SUBJECT: PANEL REPORT: REVIEW OF THE DIFFERING PROFESSIONAL  
VIEW ON A COMMISSION PAPER ON "APPLICABILITY OF SECTION  
11e.(2) OF THE ATOMIC ENERGY ACT TO MATERIAL AT THE  
SEQUOYAH FUELS CORPORATION URANIUM CONVERSION  
FACILITY" (DPV-NMSS-2001-01)

**REPORT OF AN AD HOC PANEL  
CONVENED TO REVIEW THE DIFFERING PROFESSIONAL VIEW ON  
A COMMISSION PAPER ON “APPLICABILITY OF SECTION 11e.(2) OF  
THE ATOMIC ENERGY ACT TO MATERIAL AT  
THE SEQUOYAH FUELS CORPORATION  
URANIUM CONVERSION FACILITY”**

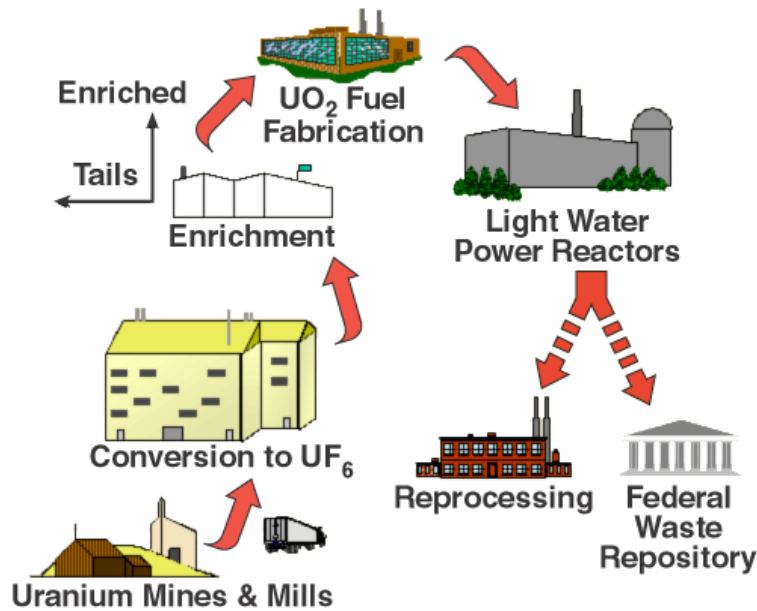
A key area of concern in the DPV by Fliegel and Lusher is the definition of byproduct material in section 11e.(2) of the AEA as amended. They contend that the waste SFC is proposing to be treated as 11e.(2) byproduct material does not fall within previously accepted definitions (see Figure 1). Therefore, they disagree with the staff preferred option in the draft Commission Paper to accept the SFC proposal. They note that the 1993 EDO memorandum stated that, "The uranium contaminated decommissioning wastes at Sequoyah Fuels do not fit the definition of 11e.(2) byproduct material and thus fall outside the coverage of the Act."

The Draft Commission Paper proposes that the front end of the Sequoyah facility can be considered as a continuation of the milling started at a facility licensed as a mill (see Figure 1). Under this view, the “ore” would be the original ore brought to the mill that supplied the yellow cake to the Sequoyah facility. The DPV argues, that if this were the case, any process at any nuclear fuel cycle facility that results in an increase in the concentration of uranium (or thorium) would have its wastes qualify as 11e.(2) byproduct material, as the uranium or thorium would have started out as ore at some uranium or thorium mill.
